SERVICE BULLETIN

APPLICABILITY: 2012MY and Later Impreza Models with FB Engine **NUMBER:** 02-141-13R
 2011MY and Later Forester, N/A and Turbo Models **DATE:** 05/28/13
SUBJECT: Design Change to Rubber Sealing Cap for Oil **REVISED:** 08/07/13
 Pressure Switch

**Original
(old style) cap**

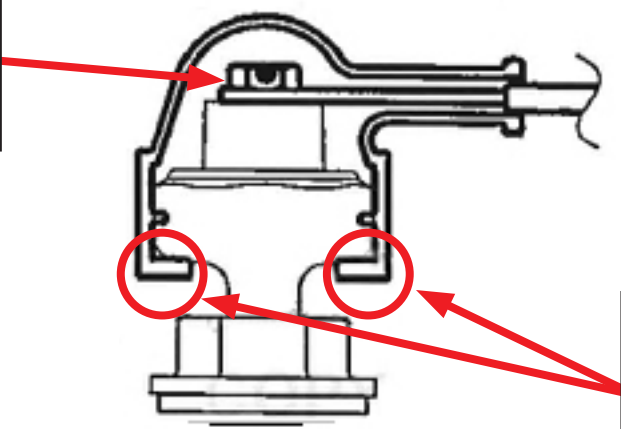
This Bulletin provides information regarding a design change to the rubber cap which covers the electrical connection at the oil pressure switch. The new cap provides better sealing and resistance to moisture intrusion which can compromise the electrical connection and in some cases, cause the oil pressure warning lamp to illuminate in error.

**4 seal breaks have
been added on the
new cap as shown.**

Be sure to follow the applicable procedure for tightening this electrical connection terminal as it varies by model.

The seal must be installed as shown with no roll-up of any of the edges.
